STATE OF NEW MEXICO

ENVIRONMENTAL EVALUATION GROUP
P.O. BOX 3149
CARLSBAD, NEW MEXICO 88220
(505) 885-9675

March 30, 1988

A CRITICAL ASSESSMENT OF CONTINUOUS AIR MONITORING SYSTEMS AT THE WASTE ISOLATION PILOT PLANT

Figure 11

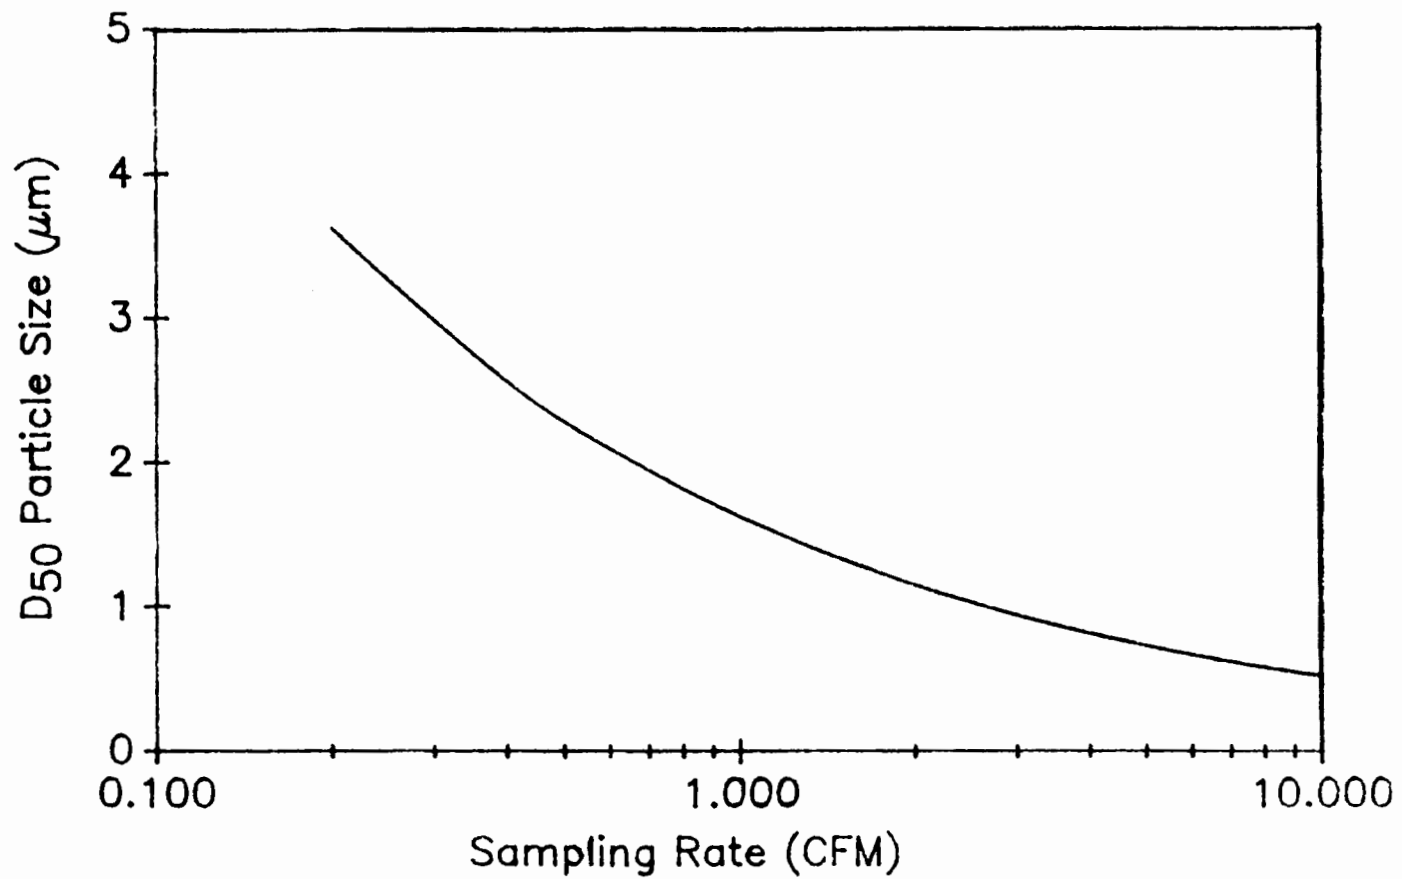
Assuming a jet diameter of 0.32 cm (0.125") and a variable flow rate of 0.2 CFM-6 CFM, the effective aerodynamic diameter for a 50% cut varies between $3.6\mu m$ and $0.66\mu m$ AED (see Fig. 11). The corresponding percentage of sample loss due to impaction cannot be predicted without knowing the particle size distribution of the sample. But clearly, if the mass median aerodynamic diameter is large, a very substantial fraction of the sample will be lost.

There would be varying amounts of smaller-size particles lost as well to impaction on the far wall of the CAM chamber. Depending on location in the underground drifts or rooms or in the exhaust stack, losses of substantial fractions of larger aerodynamic diameter particle components of sample, as predicted by this model, could have a severe effect on CAM performance. In underground areas near mining operations, or in areas of high traffic the mean diameter has been found to be much larger than in more remote areas. Also, in the case of accidental release, the mean aerodynamic diameter could be much larger than under normal conditions. Hence, impaction losses will have to be demonstrably controlled before the CAM can be considered a truely operational instrument.

Figure 12

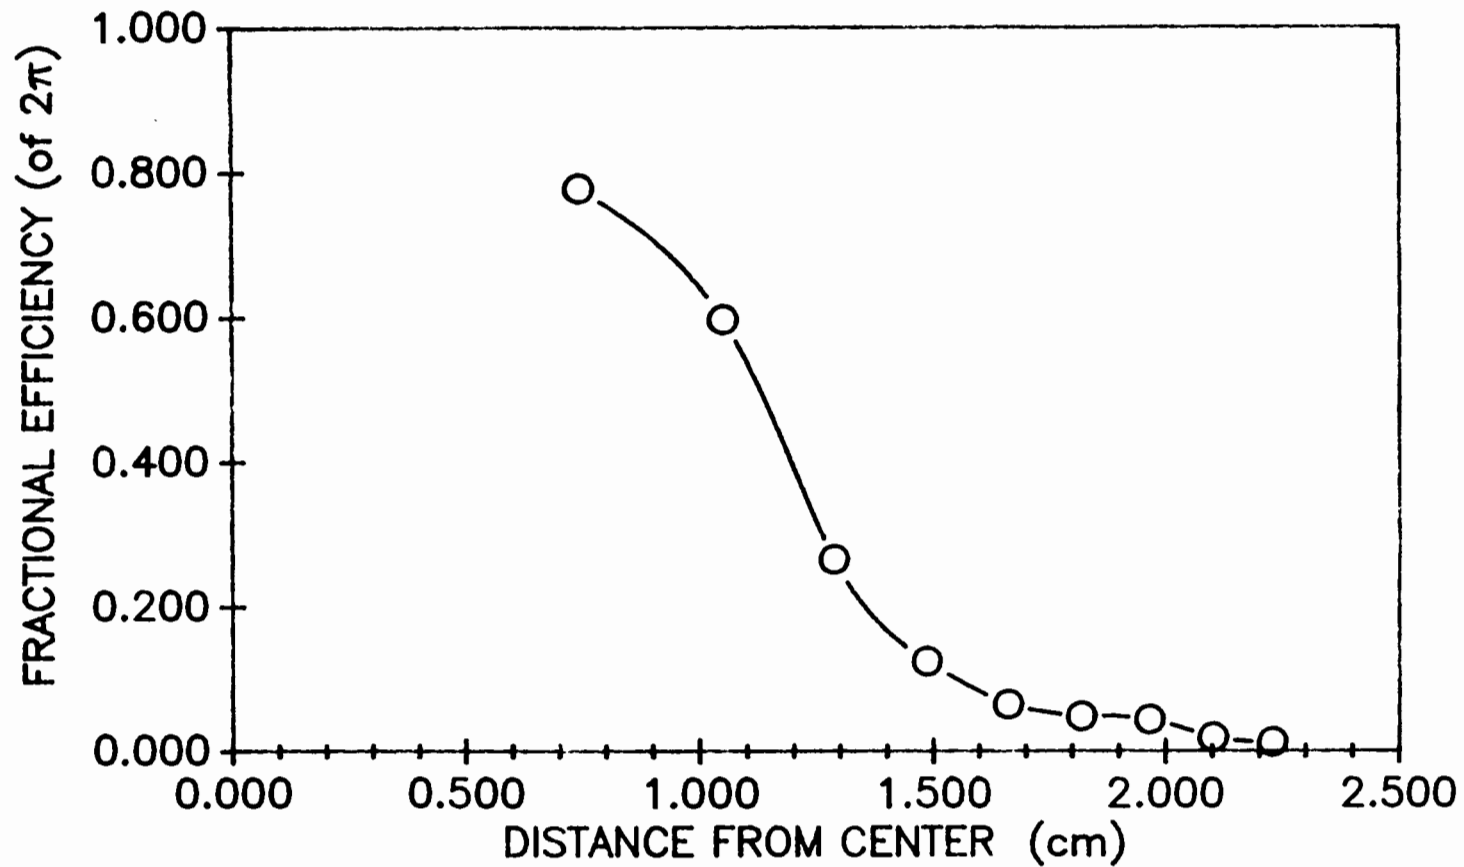
In order to further study the problem of non-uniform sample deposition, the consequences for detector efficiency of particulate deposition location on the filter was explored with the detector response model described in Chapter 2. The surface of the filter, which is coaxial with the detector, was modeled as if it were divided into 9 concentric rings, each of which having about equal area. Then the source of each photon arriving at the detector (whether absorbed or not) was determined, as well as the total number leaving each area. The ratio of the total number of hits on the detector to the number leaving each area is then a measure of the efficiency for detection as a function of distance from the center. The result, shown in Fig. 12, reveals that indeed for the geometry of the NRC CAM head, the efficiency drops rapidly and significantly from about 80% of 2π near the center of the filter to less than 2% near the edge. Therefore, for the larger-particle size fraction of the sample deposited toward the far side of the chamber from the jet entrance, the detection efficiency would be very significantly reduced, even more than reported by Biermann and Velen for the alpha CAM they investigated.[16] Increasing the CaF_2 detector size to match the filter size does apparently improve the detection of off-center sources, based on model simulation. The efficiency near the edge is then closer to 75% of 2π.
